ADDENDUM NO. 3

QUESTIONS and RESPONSES

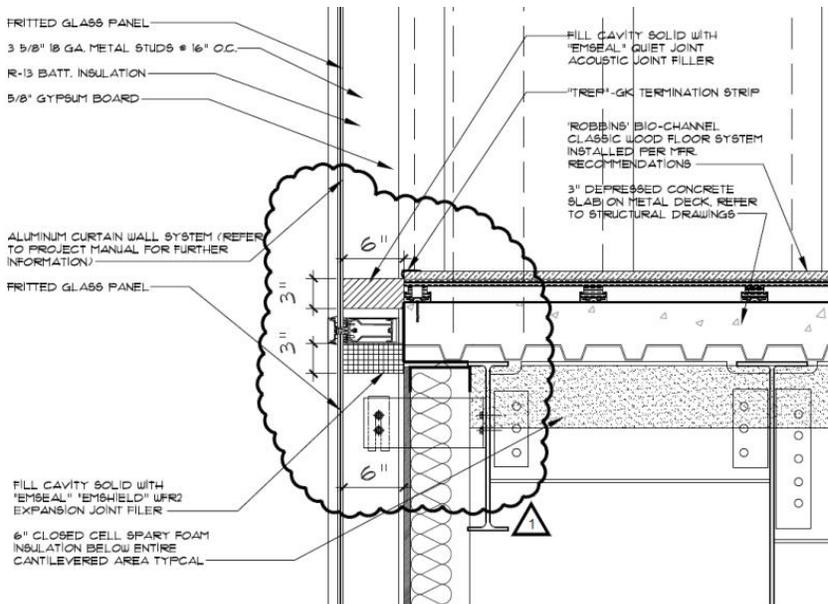
3-13 Reflected ceiling plans legend states CL-7 as "same as CL-6 with acoustic coating". Does this mean everywhere designated CL-7 is receiving sprayed cellulose fiber per spec section 072129?

Answer: Sprayed "acoustic" insulation shall be applied at all CL-7 ceilings. Spray-applied cellulose acoustical finish, such as k-13, by International Cellulose Corporation, can be used at these ceilings. The k-13 should be sprayed to a thickness of 1.5 inches in the single height spaces and 3 inches in the double height spaces
